Office Action Summary

Application No. 10/726,767	Applicant(s) NIXON, MARGARET MARIE	
Examiner Michael G. Mendoza	Art Unit 3731

DETAILED ACTION

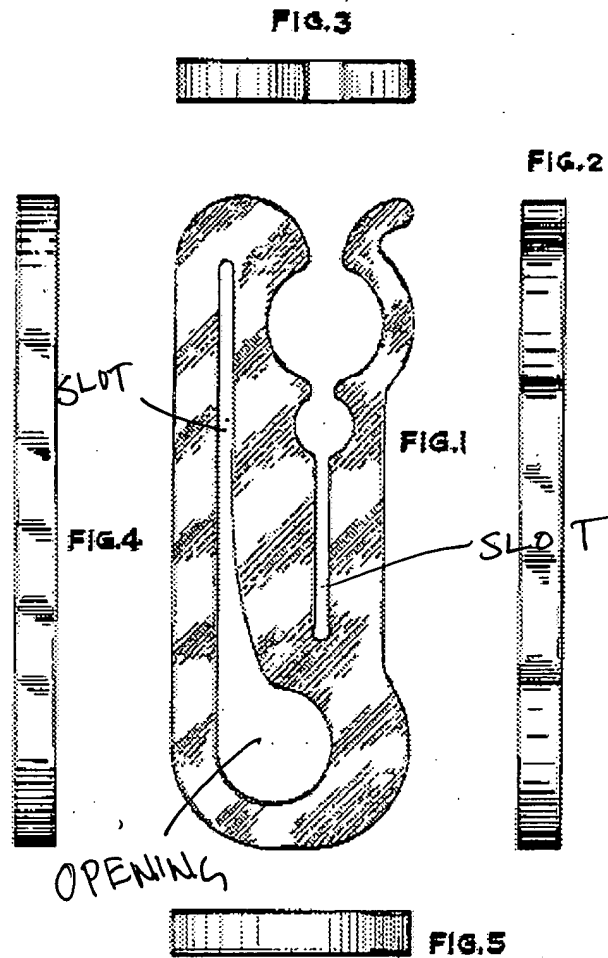
7. Claims 1, 3-6, and 8-10 are rejected under 35 U.S.C. 102(b) as being anticipated by Lock Des. 233312.

8. Lock teaches a tensioner for a surgical tape, the tensioner comprising attaching means; holding means; wherein the attaching means comprises an elongated slot through the unitary tensioner body; wherein the holding means comprises a circular opening through the unitary tensioner body; and wherein the holding means comprises an elongated slot through the unitary tensioner body.

FIG. 1

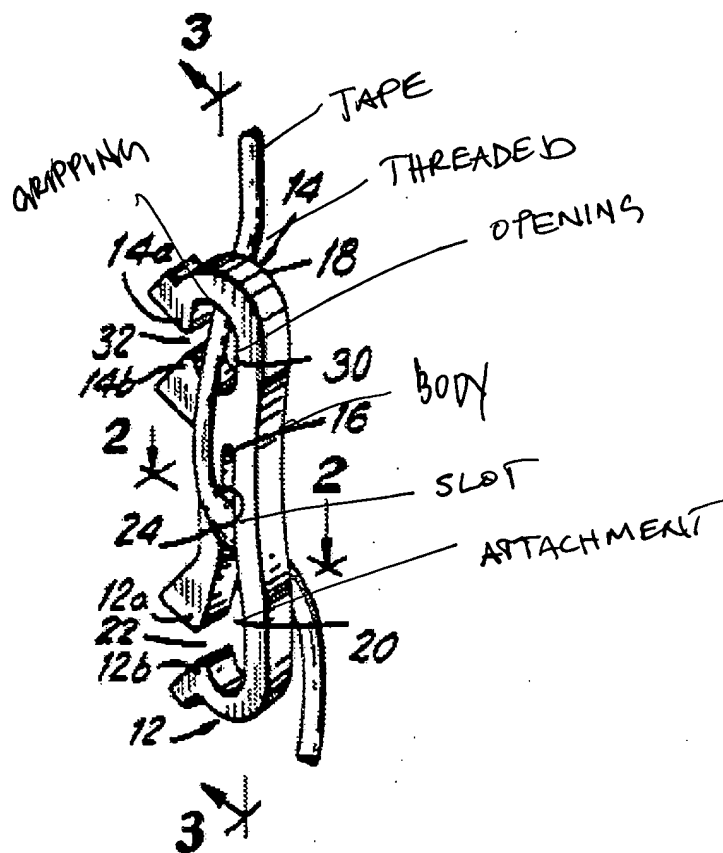
9. Claims 11-13 are rejected under 35 U.S.C. 102(b) as being anticipated by Skakoon 5232193.

10. Skakoon teaches a method of clamping, the method comprising the steps of: attaching a tensioner, having a unitary body, to a length of surgical tape; passing a portion of the surgical tape around the elongated body structure; and securing the surgical tape in place by inserting a section of the surgical tape into a gripping portion of the tensioner; wherein the attaching step comprises securing a free end of the length of

surgical tape in a slot in the tensioner; wherein the securing step comprises threading the length of surgical tape through an opening in the tensioner.
